## Joint IEEE P802.3ct / P802.3cw Task Force Interim Teleconference

#### Comment #i-1 - Black Link Definition and Terminology

John D'Ambrosia, Futurewei, U.S. Subsidiary of Huawei IEEE 802.3 Dec 14, 2020 Interim Teleconference Meeting

Figure 154–3—Example configuration of the black link approach

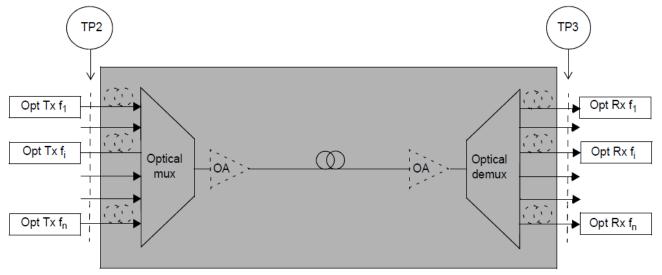
# Additional Meaning to "Black Link" in D3.0

The presence of one or more optical add-drop multiplexers (OADMs) is not directly assumed but also not specifically excluded as long at the end-to-end link requirements are met. The arrangement of (DWDM) elements within the black link shown in Figure 154–3 is not intended to place constraints on the construction of the black link, but simply to define the location of the single channel interfaces at TP2 and TP3. To visualize that specifying details of the black link is <u>outside the scope of this clause, the black link in Figure 154–3</u> is shown as a grey shaded box, where certain elements are shown only for illustrating one example.

No definition has been defined for the aggregate of DWDM channels or exists in Clause 1.4, but the text in 154-6 appears to suggest that this is also the "Black Link"

- Current "Black Link" definition per 1.4.160a
  - Methodology not a description of the DWDM channel(s?) between (PHYs / MDIs / TP2-TP3)
  - Not clear if it refers to a single or all DWDM channels
- Secondary "definition" for Black Link inside of noted Clause 154-6.
  - This definition conflicts with the definition noted in 1.4.160a, which refers to black link as a methodology.
  - No supporting definition inside 1.4
- It is the author's opinion that this terminology issue is causing confusion between individuals while working on both 802.3ct and 802.3cw and would, therefore, also cause confusion to individuals reading the anticipated standards, if this is not corrected.

- Perhaps current "black link" term should be changed to "black link methodology" and updated per response to i-1
    - Add additional definition "black link" that refers to the aggregate of DWDM channels, as illustrated in Fig 154-3.

- The scopes of both projects <u>may</u> need updated to address the noted "DWDM system" issue.
  - 2. Consider redefining "DWDM system" to be what is defined in Clause 154.6 / Fig 154-3. See Slide #7

## Proposed Update to "DWDM System" Definition

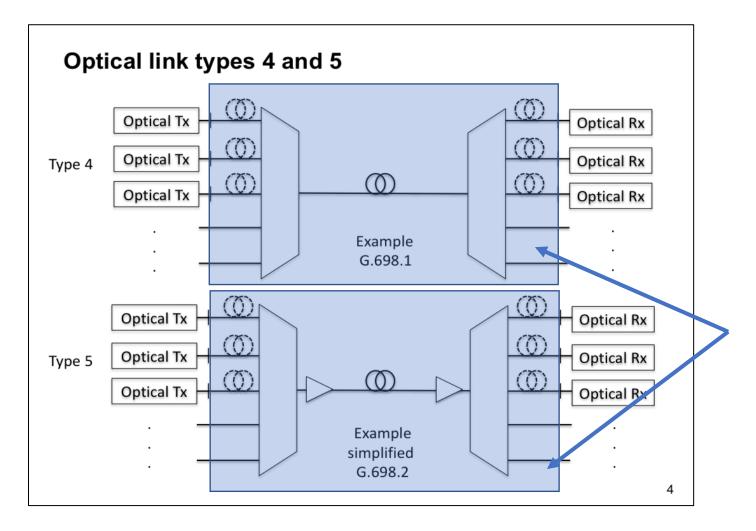
Lack of clearness in the scope of both projects. Perhaps "DWDM System" is best applied to the aggregate of DWDM channels.

Proposed Update to "DWDM System" - An aggregate of DWDM <del>links</del> <u>channels</u> optically multiplexed and demultiplexed onto and off either a single optical fiber or a single optical fiber per direction.

- Modify "Black 'link" definition as per response to i-1
    - Potential re-definition for **1.4.237d DWDM system** An aggregate of DWDM links channels optically multiplexed and demultiplexed onto and off either a single optical fiber or a single optical fiber per direction.
